SUBJECT: **Request for Permit Modification of CAMA Major Development Permit** for the Proposed Replacement of the Lindsay C. Warren Bridge (Tyrrell County Bridge No. 7) on U.S. 64 over the Alligator River/Atlantic Intracoastal Waterway in Tyrrell and Dare Counties, North Carolina. STIP Project No. HB-0001; Federal Aid Project No. NHPB-0001.

REFERENCE: CAMA Major Development Permit, Permit No. 136-23. Issued November 30, 2023.

The purpose of this letter is to request modification of the existing CAMA Major Development Permit to include these activities. In addition to this letter, revised permit drawings showing test pile locations and impacts, mapping and a construction detail of mooring pile locations, and a construction detail of test piles are also included.

HB-0001 Alligator River Bridge Project
Proposed Mooring Pile Locations
Aerial Map

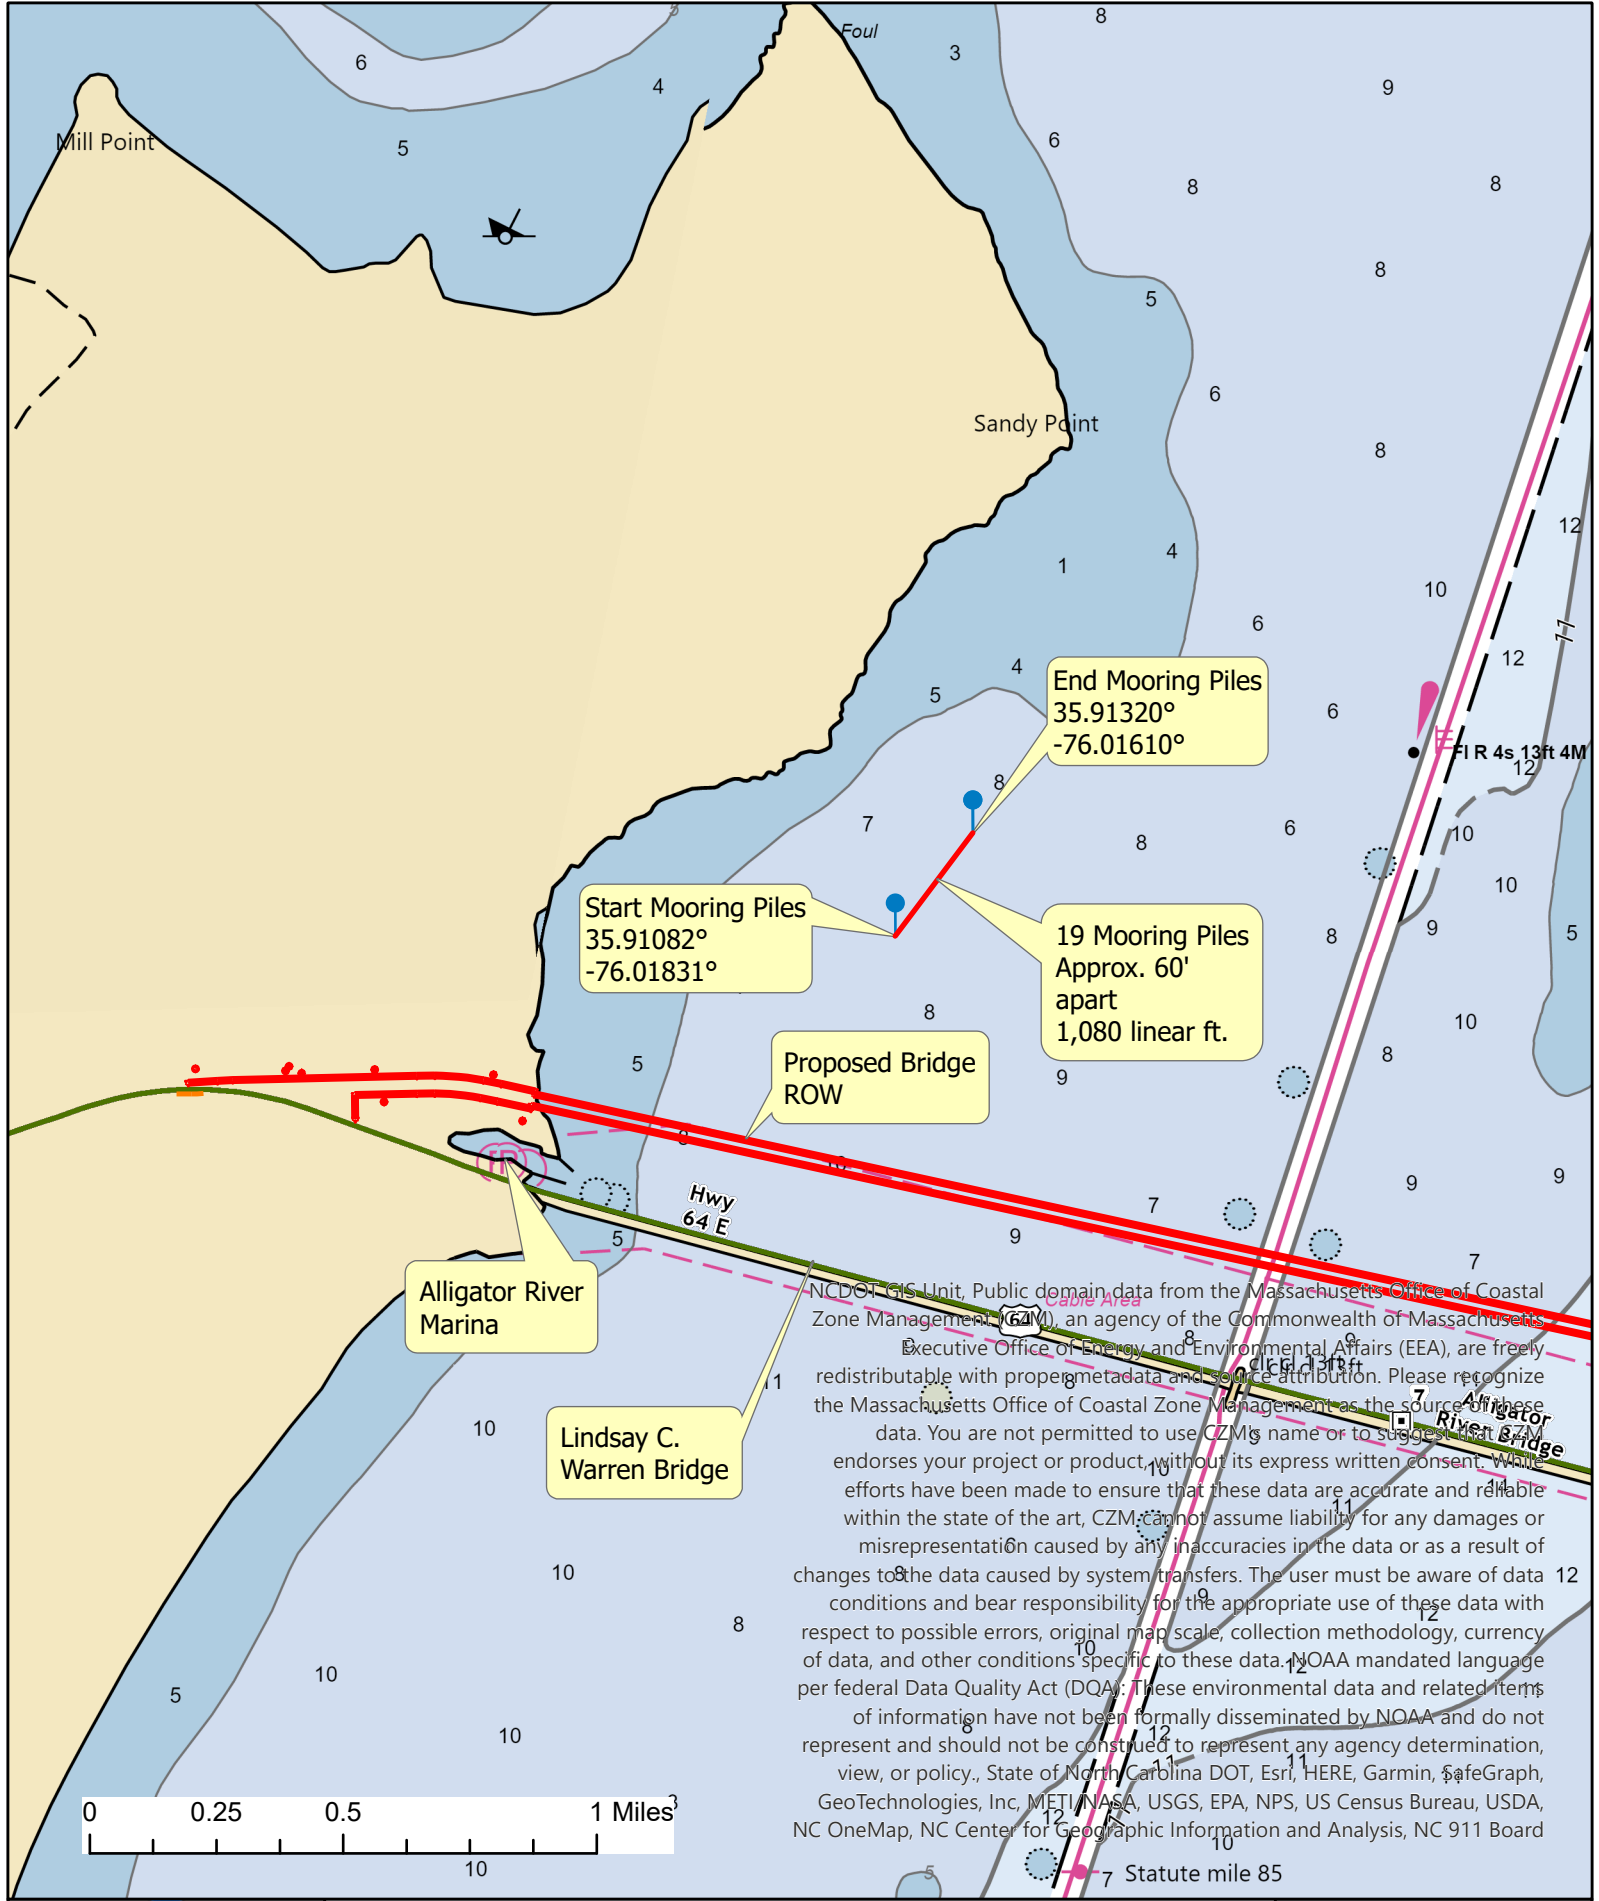
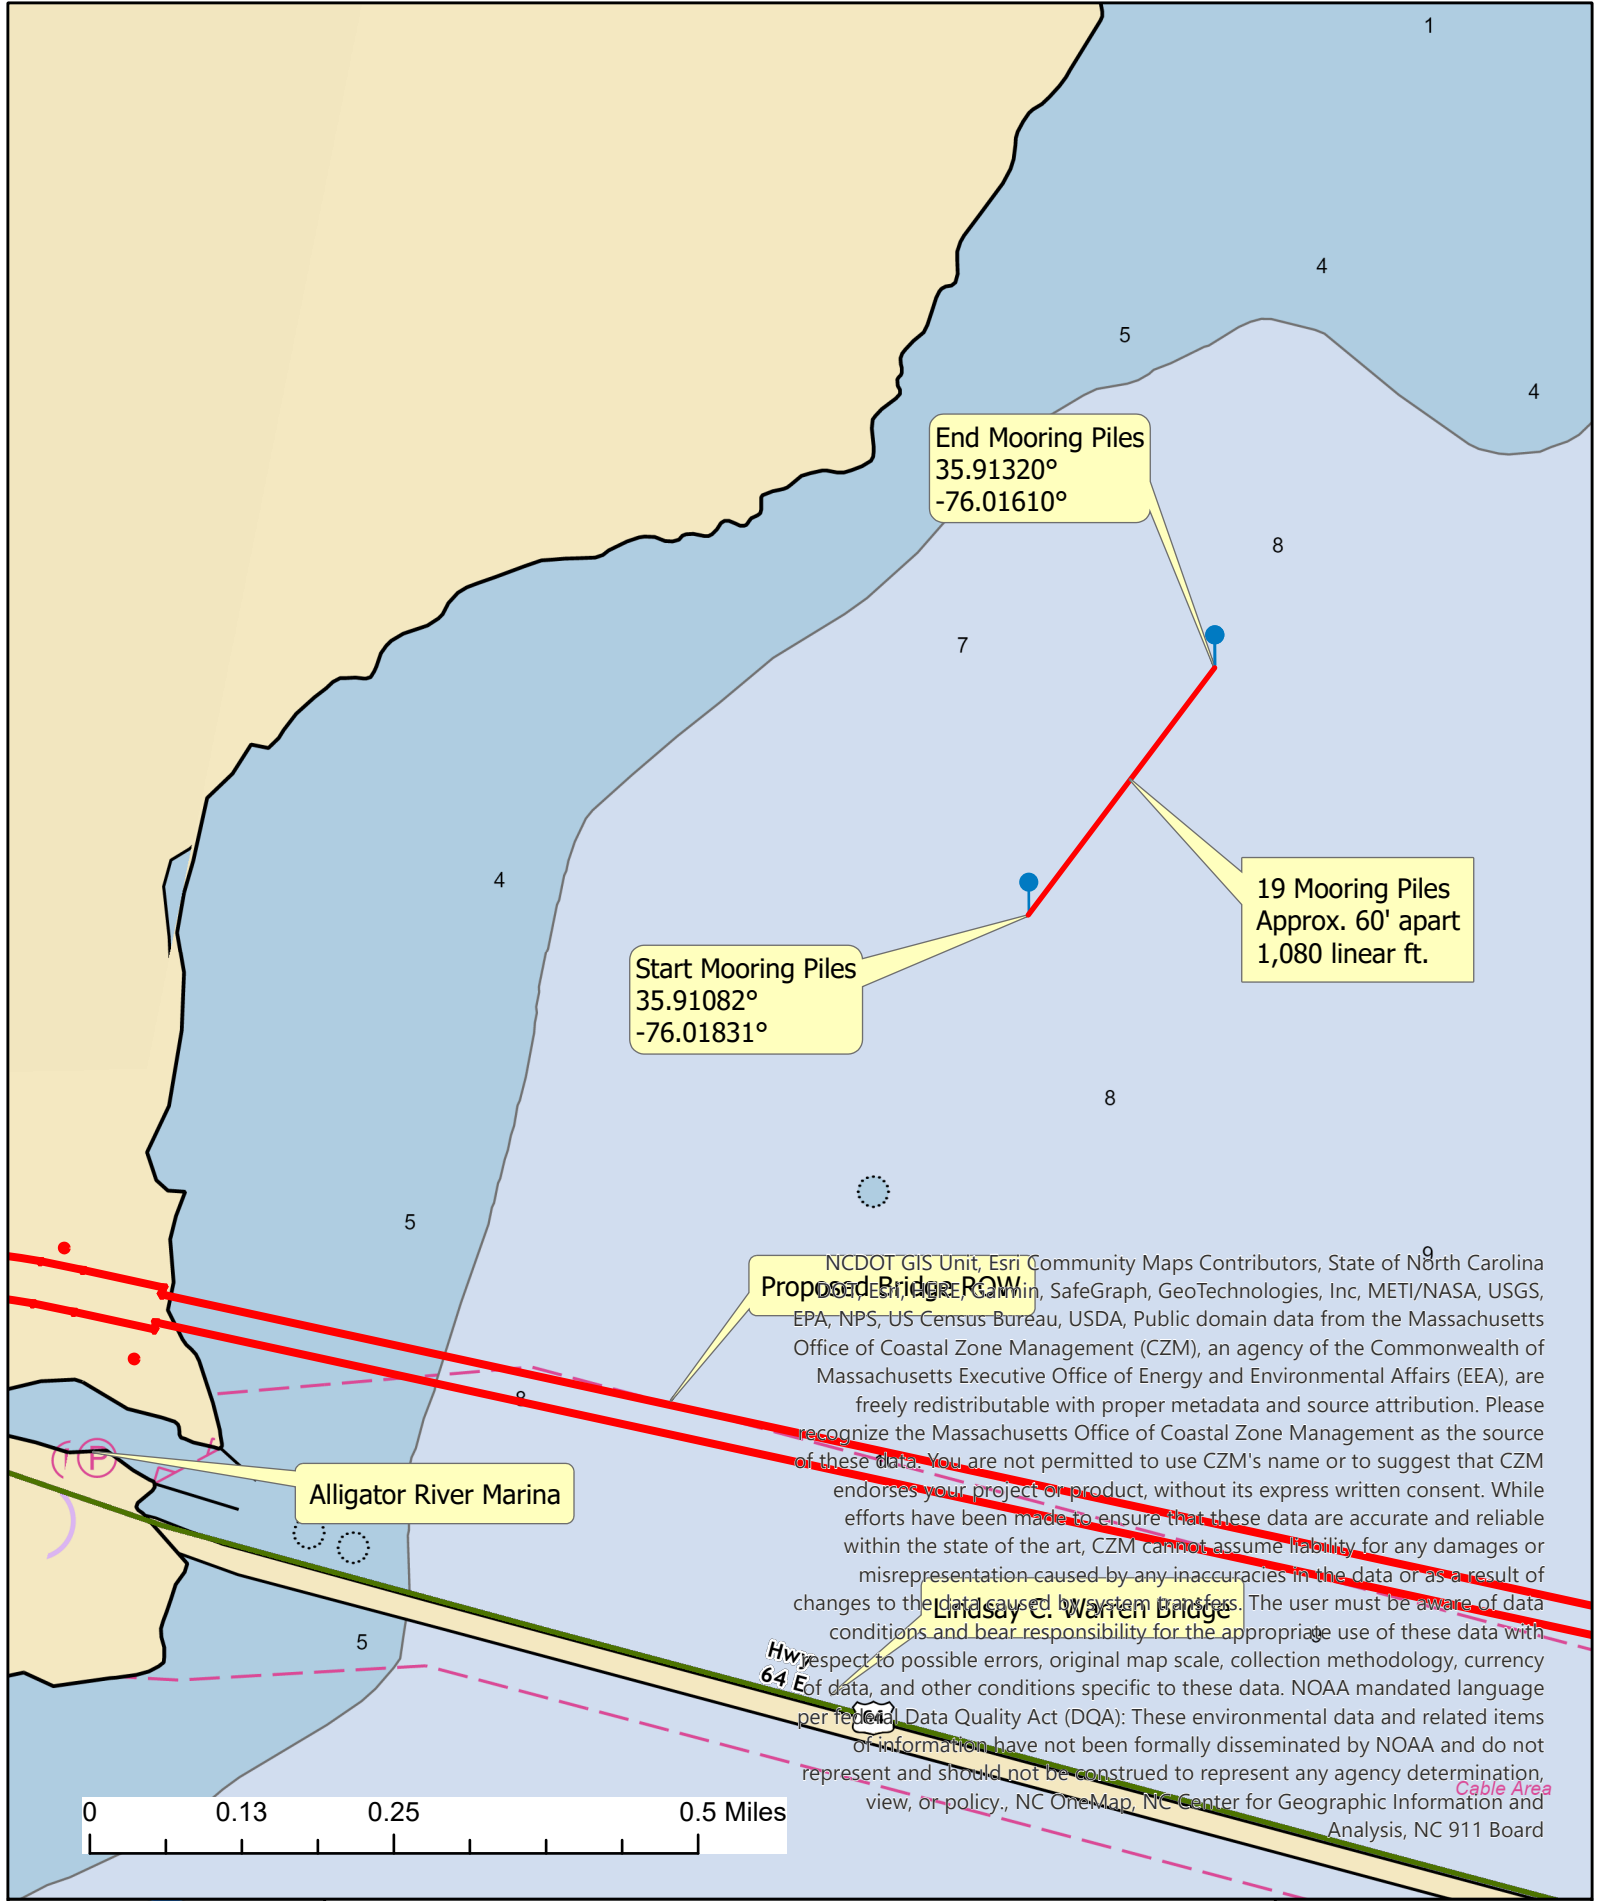
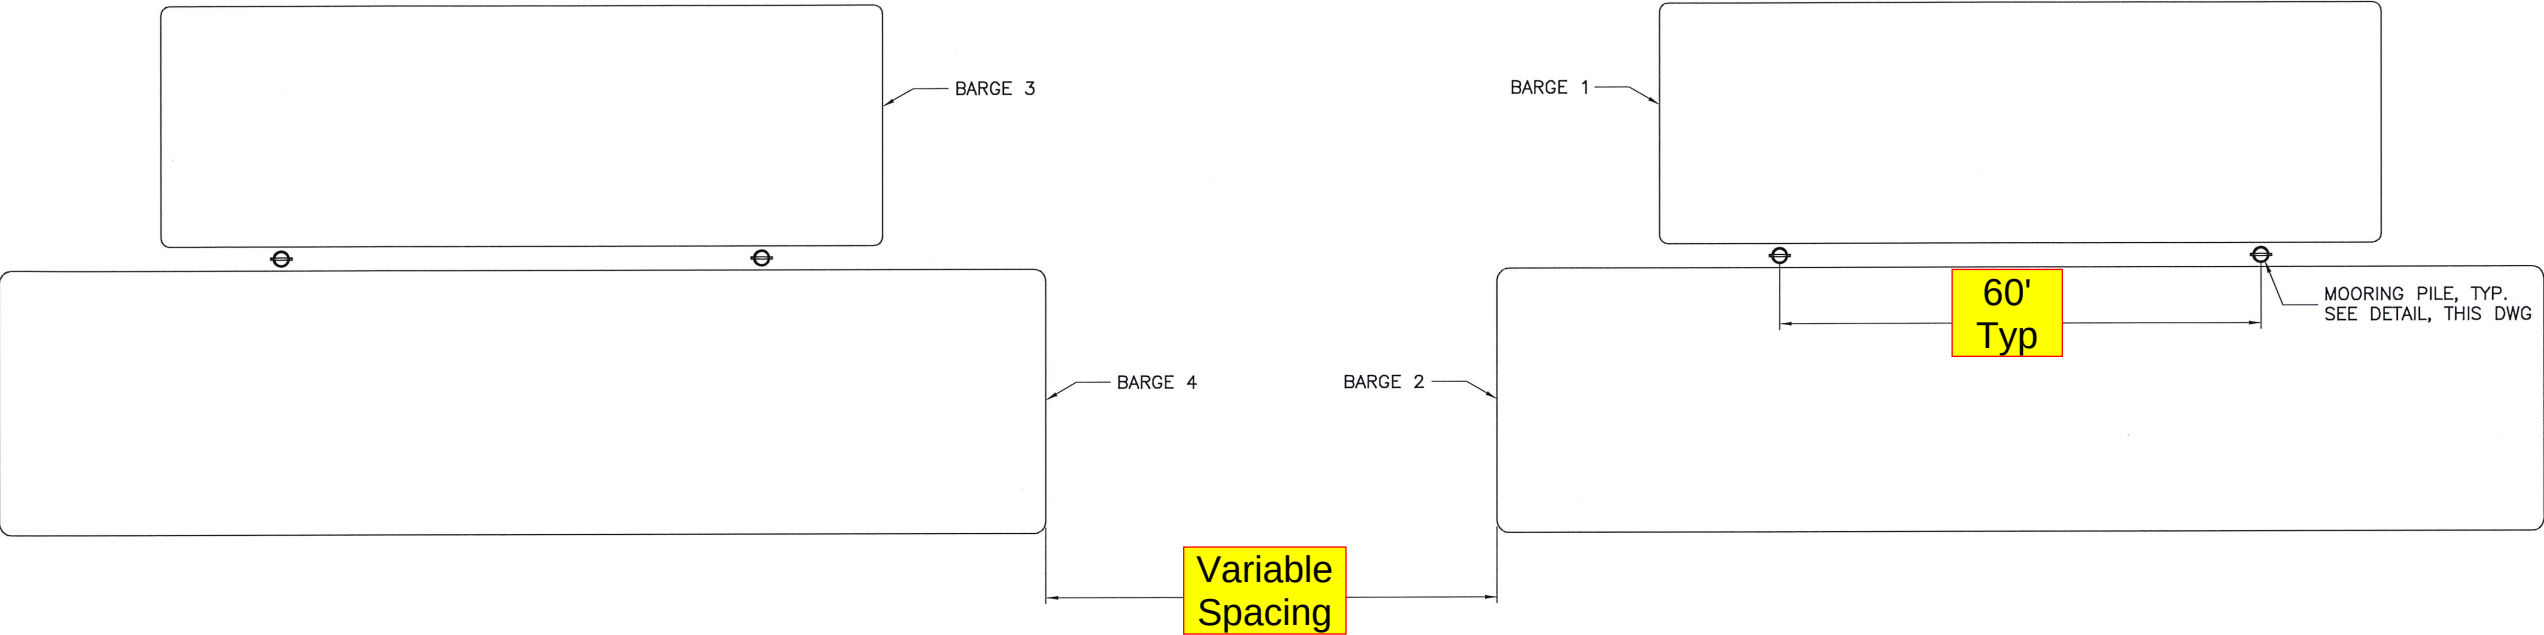
The use of temporary mooring piles is proposed for securing barges in place for test pile study and bridge construction. Thirty-inch steel pipe piles will be installed approximately 60 feet apart, from coordinates 35.91082, -76.01831 to 35.91320, -76.01610, total 19 mooring piles. The pile installation will span approximately 1,080 linear feet. Please see attached mapping showing the proposed mooring pile locations and mooring pile detail.

The mooring location has sufficient water depths for barges and tugboats and is outside any navigation channels that could conflict with boat traffic. Once the project is complete, these mooring piles will be removed.
